# Staff Technical Position on Regulatory Considerations in the Design and Construction of the Exploratory Shaft Facility

Manuscript Completed: April 1991  
Date Published: July 1991

**Division of High-Level Waste Management  
Office of Nuclear Material Safety and Safeguards  
U.S. Nuclear Regulatory Commission  
Washington, DC 20555**

FIGURE 1 -- An example of an acceptable approach to achieve compliance of the ESF design with 10 CFR Part 60 requirements. Refer to the text in Section 4.0 (Technical Position No. 1) for a discussion of this approach.

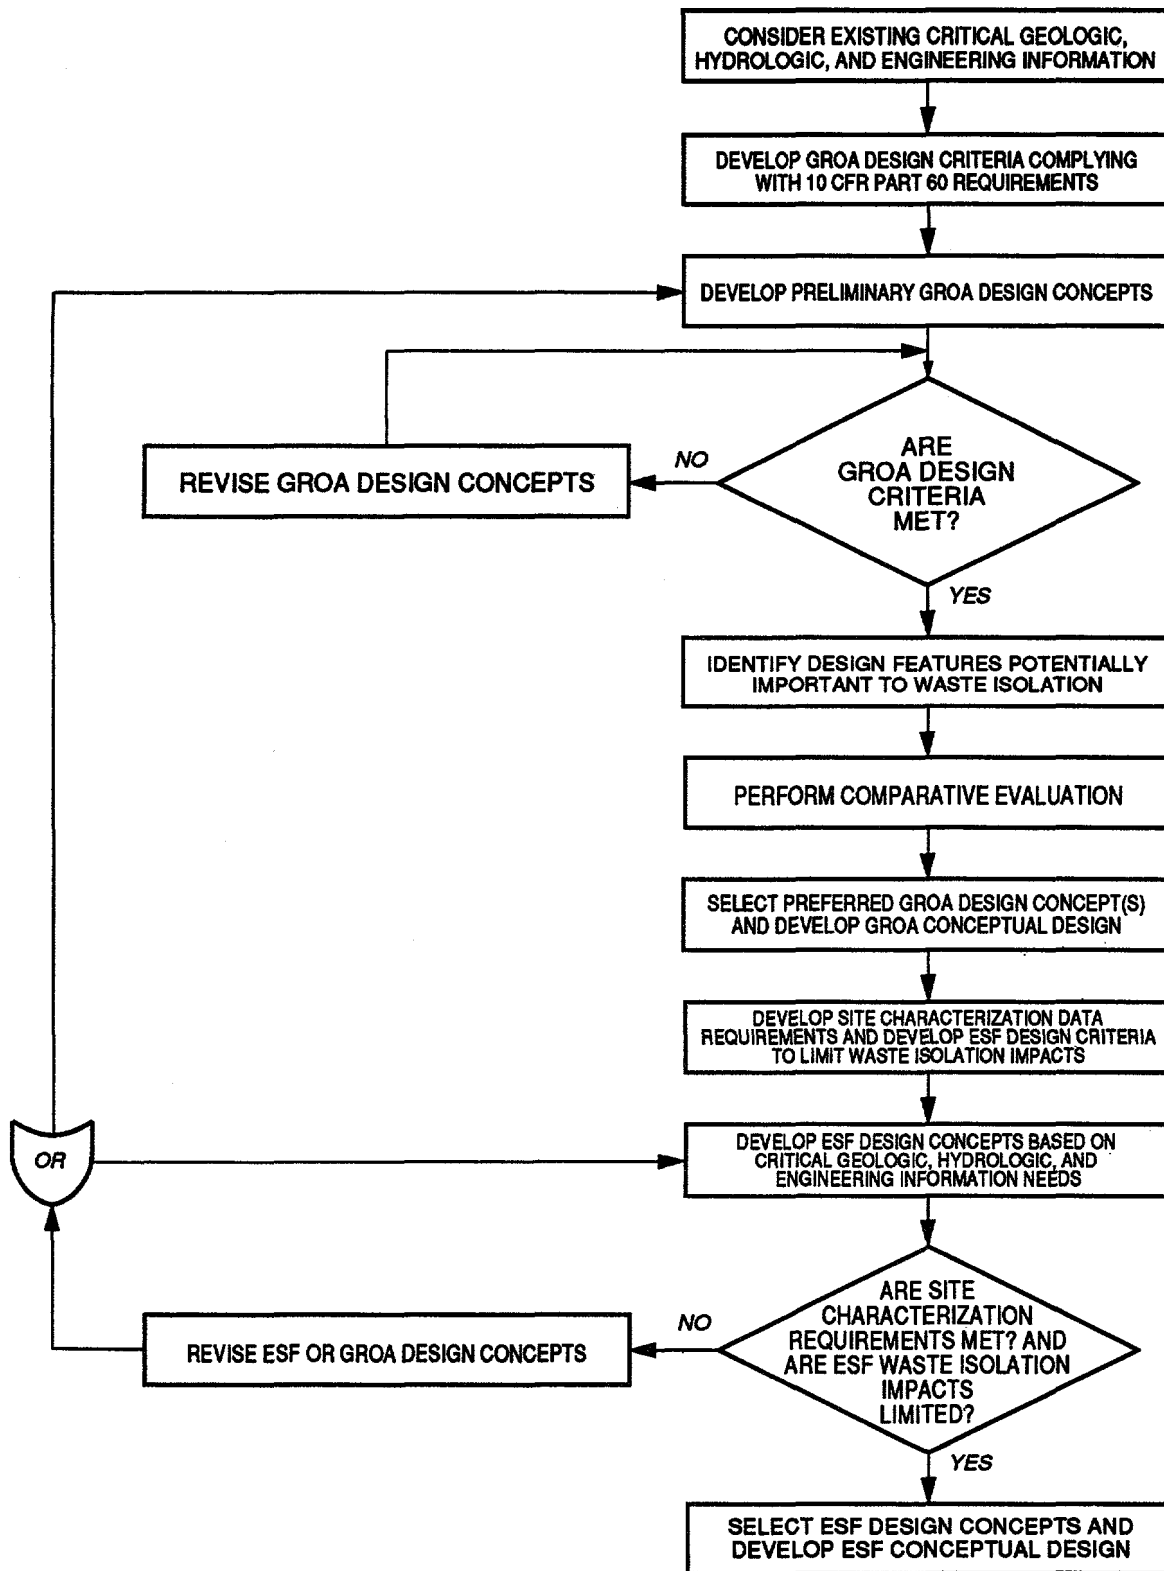
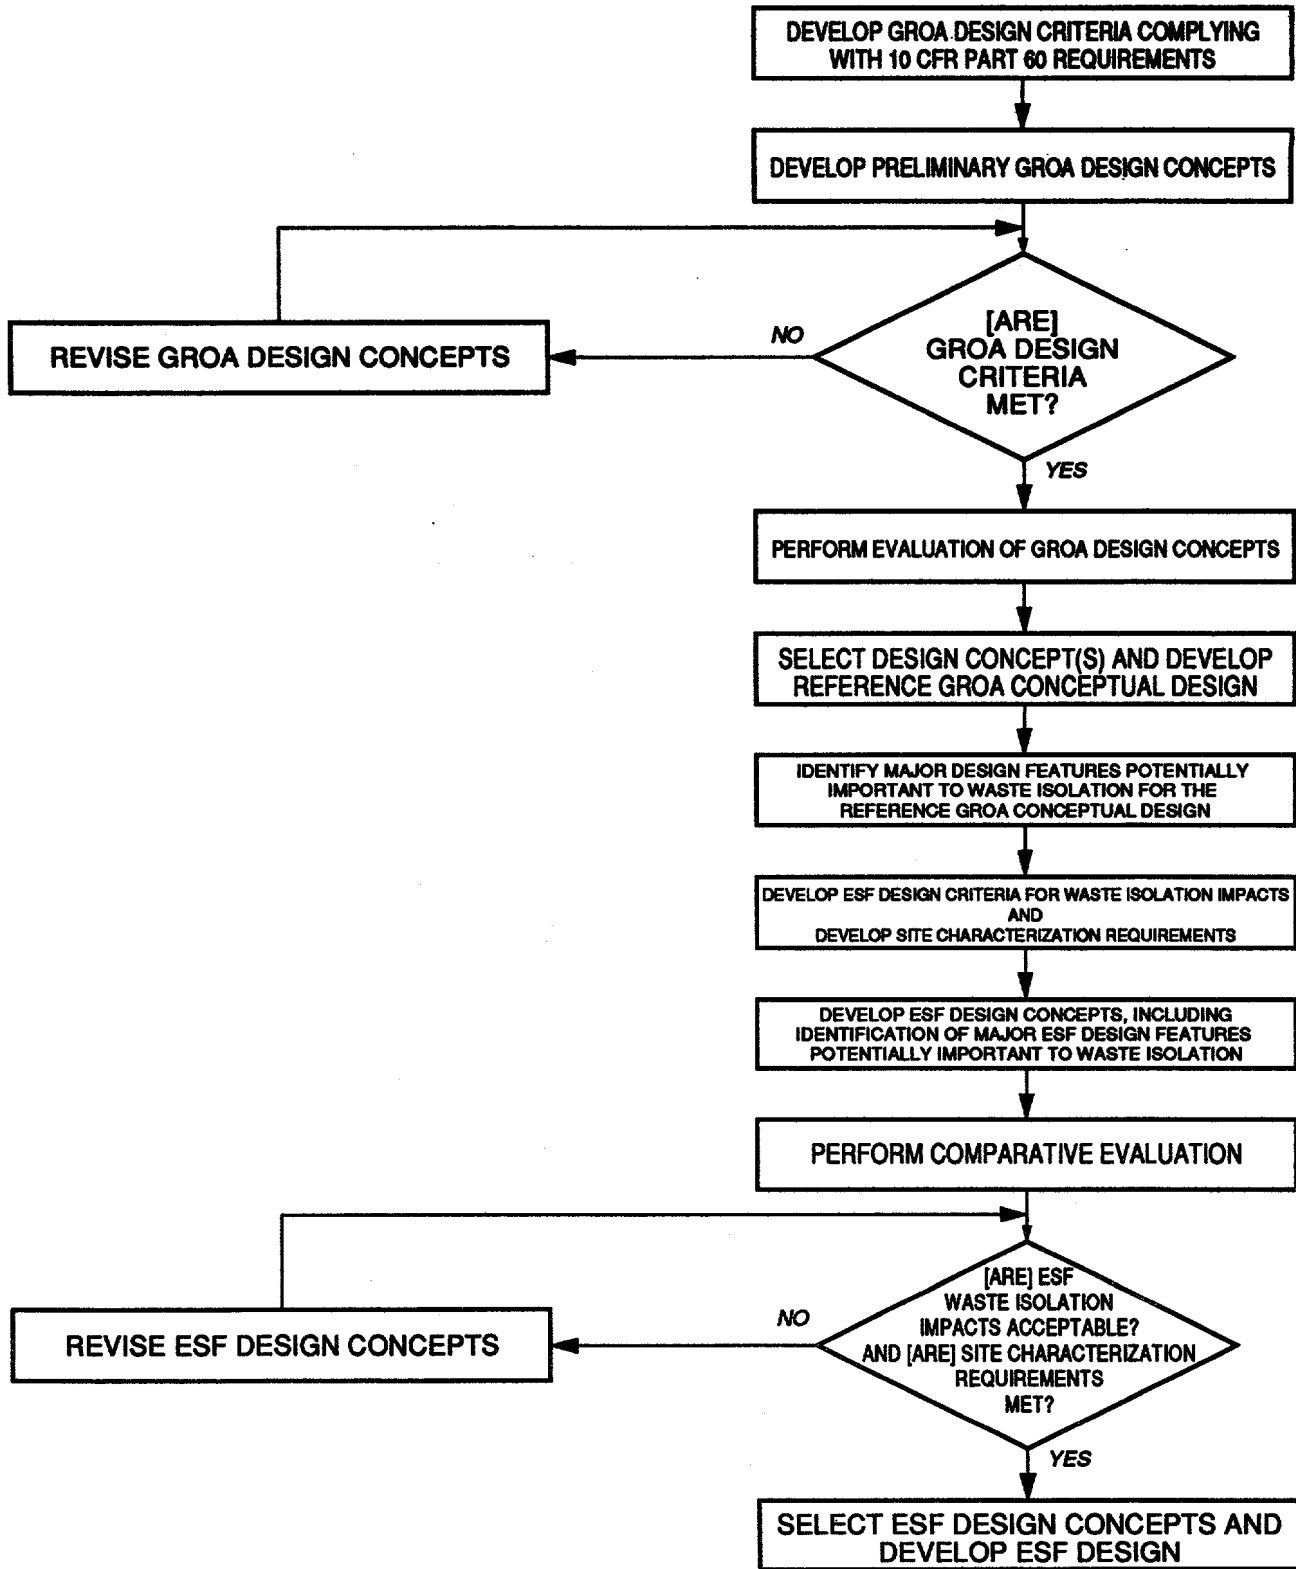
Figure 1 of the TP also introduces the concept of "minimizing" waste isolation impacts, which we believe is beyond the intent of the regulations. 10 CFR 60.15(c)(1) indicates that such impacts should be limited "to the extent practical," which implies that they be acceptable. The revised Figure 1 [Figure D1] also provides recommended changes to this.

This statement, as well as Figure 1, implies that a GROA conceptual design has not yet been developed by DOE. In fact, the SCP includes a GROA conceptual design as required by the NWPA and 10 CFR 60.17(c). See SCP, Vol. VI. Figure 1 provides a graphic confirmation of the inverted priority assigned by the TP to the purpose of the ESF by totally subordinating it to the GROA design. A more fundamental problem with Figure 1 is that it assumes the necessity for compliance of the ESF design with 10 CFR Part 60, when there is no basis for such an assumption.

Why doesn't Figure 1 reflect the statement in the STP that "In reality, we recognize that both efforts (ESF and repository (i.e., GROA) design) may well proceed simultaneously ..., " et cetera.

The staff agrees with the comment that the waste isolation impacts should be limited "to the extent practical" and they need not be minimized. However, should a design feature be acceptable and, based on existing information, an alternative to this feature is known to have significant advantages, the alternative design feature should not be dismissed merely because the original design feature was acceptable. In this context, the staff has revised the phrase in the process block in Figure 1 reading "Develop ESF Design Criteria to Minimize Waste Isolation Impacts" with the phrase "...Develop ESF Design Criteria to Limit Waste Isolation Impacts."

Also, in the same figure, the process block reading "ESF Waste Isolation Impacts Minimized and Site Characterization Requirements Met?" now reads "Are Site Characterization Requirements Met? and Are ESF Waste Isolation Impacts Limited?" The discussion (in Section 4.0) behind Technical Position No. 1, has been revised accordingly, to track with these changes.

As regards the ACNW's comments on the modification of the flow chart presented in Figure 1, the staff has modified the figure and the text in Item (1) of Section 4.0, accordingly. Four ACNW-recommended changes were made to Figure 1: (1) The addition of a new process block entitled "Consider Existing Critical Geologic, Hydrologic, and Engineering Information" at the beginning of the example approach; (2) changing of the title of the process block entitled "Develop ESF Design Concepts" to "Develop ESF Design Concepts Based on Critical Geologic, Hydrologic, and Engineering Information Needs"; (3) the connection of the two process blocks entitled "Revise ESF or GROA Design Concepts" and "Develop Preliminary GROA Design Concepts" by an activity line (through an "Or" gate); and (4) the shifting of an activity line from the "Revise ESF or GROA Design Concepts" process block to a new position (through an "Or" gate) as input to the process block entitled "Develop ESF Design Concepts" from an original position that was between "Develop ESF Design Concepts" process block and the decision block entitled, "Are Site Characterization Requirements Met? and Are ESF Waste Isolation Impacts Limited?"

This comment is noted. The staff considers that although it is possible to proceed with the design of the ESF and the GROA simultaneously, this approach is not likely to be used. Therefore, Figure 1 does not reflect this approach. However, the approach shown in Figure 1 is only one of the acceptable ways DOE can proceed with the ESF design process. It does not preclude DOE from using other possible acceptable approaches.
